- 1. Kenaitze Estates Subdivision Fall Addition No. 2**  
**KPB File 2024-058**  
**Johnson Surveying / Fall**  
**Location: Funny River Road & Anglers Roost Street**  
**Funny River Area / Funny River APC**

**ITEM #1 - PRELIMINARY PLAT  
Kenaitze Estates Subdivision No. 2**

<b>KPB File No.</b>	2024-058
<b>Plat Committee Meeting:</b>	June 24, 2024
<b>Applicant / Owner:</b>	Randy Fall – 34915 Poppy Wood St., Soldotna, AK 99669
<b>Surveyor:</b>	John Segesser – Segesser Surveys
<b>General Location:</b>	Funny River Road Mile 14, Soldotna, AK / Funny River APC

**Kenaitze Estates Subdivision  
Fall Addition No. 2**

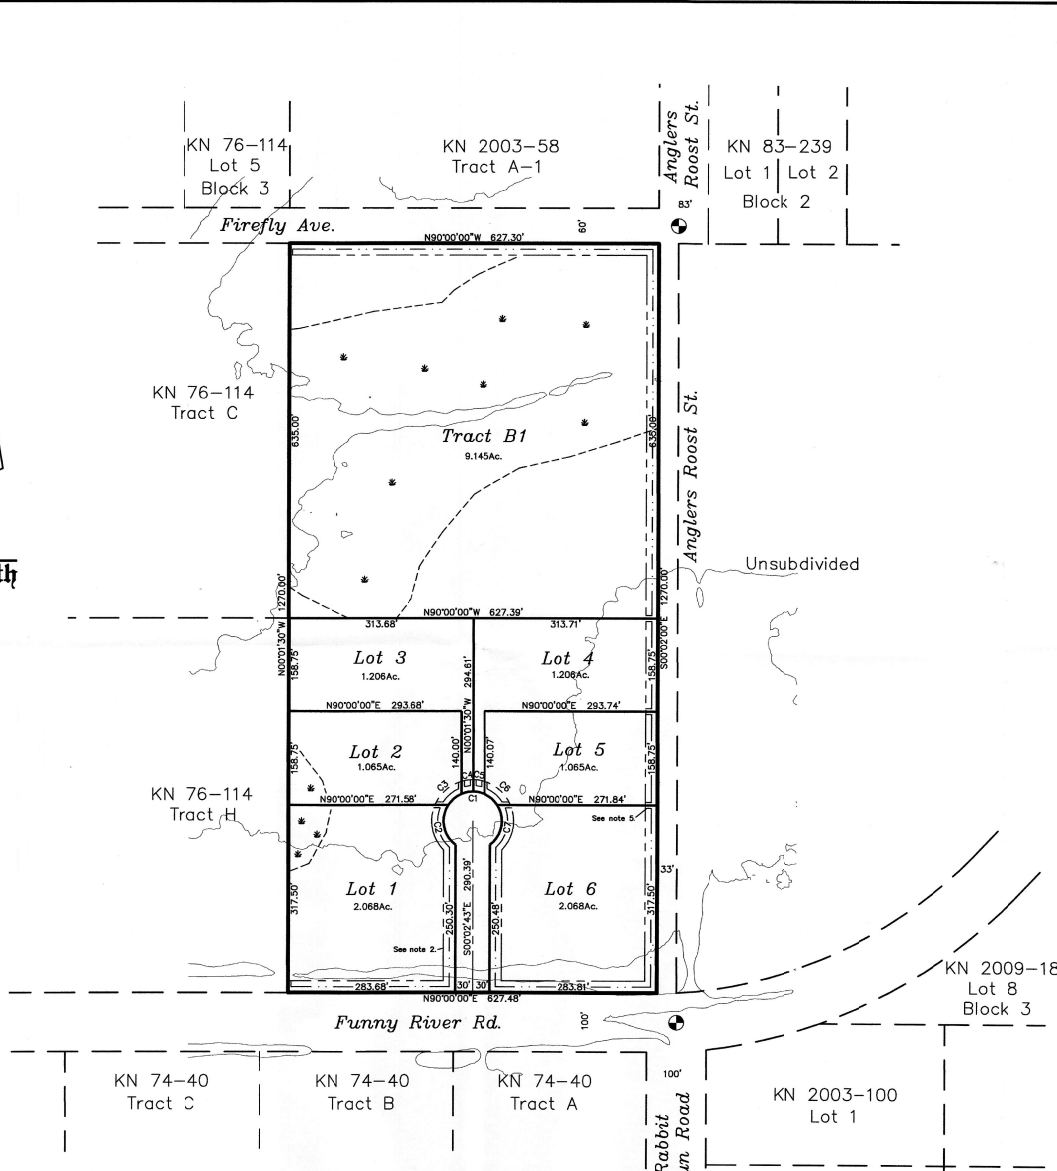
**Location and Legal Access (existing and proposed):** Existing access to the proposed subdivision is from the north side of Funny River Road at approximately mile 14. There is a 50 foot section line easement along Funny River Road that the surveyor needs to verify and show if confirmed.

Anglers Roost St. is a 33’ undeveloped dedication provided by dedication along the east of the proposed subdivision and also as a possible 33 foot section line easement then needs verification and shown if confirmed. Firefly Ave. is a 60’ undeveloped dedication lying to the north providing access for Tract B1. Funny River Road is a 100’ paved and developed state-maintained dedication, accessed from the Sterling Highway.

A 250’ foot cul-de-sac dedication is proposed by this platting action which will be accessed from Funny River Road for proposed Lots 1-6. The cul-de-sac is currently unnamed. Staff recommends: the surveyor contact the Addressing Officer and confirm a suitable name for the cul-de-sac to meet standards for a name.

There are wetlands identified by KPB wetland assessment data the area of drainageway is shown as wetlands but the area of Kettle is not labeled. KPB River Center review did not identify the property to be located in a FEMA flood hazard area or a habitat protection district.

There does appear to be a tower located on proposed lot 1. Filing 2017-010961-0 mentions a occupancy agreement and an exclusive easement that appear to affect this property. Surveyor needs to clarify and note on the plat these items.

There does not appear to be any encroachments to or from property across lines, however, there are structures located on proposed Lot 1 and any possibility of encroachments should be verified by the surveyor.

<p>There are not any Local Option Zoning District issues with this proposed plat.</p> <p>Material Site Comments:  There are not any material site issues with this proposed plat.  Communication Tower, driveway and utilities should be shown/labeled in the Southwest corner of Lot 1.</p>
Assessing	<p>Reviewer: Windsor, Heather  Comments: No comment</p>
Advisory Planning Commission

- Update KPB file number to 2024-058.
- Lot 8 to the east needs Block changed to 1
- Provide KPB approved name for cul-de-sac.
- Add Certificate of Acceptance.
- Depict and provide detail on plat to match items in legend.

**Staff recommendation:**  
Depict section line easement along eastern & southern boundary of section.
- D. A vicinity map, drawn to scale showing location of proposed subdivision, north arrow if different from plat orientation, township and range, section lines, roads, political boundaries, and prominent natural and manmade features, such as shorelines or streams;

**Staff recommendation:**  
Label Anglers Roost St and remove Lake St on vicinity map
- F. The location, width and name of existing and platted streets and public ways, railroad rights-of-way, easements, and travel ways existing and proposed, within the subdivision;

**Staff recommendation:** Provide name for cul-de-sac.

**Staff recommendation:** place the standard note on the plat for the flag lot(s): No structures are permitted within the panhandle portion of the flag lot(s).

Depict and provide detail on plat to match items in legend.

Add Certificate of Acceptance.
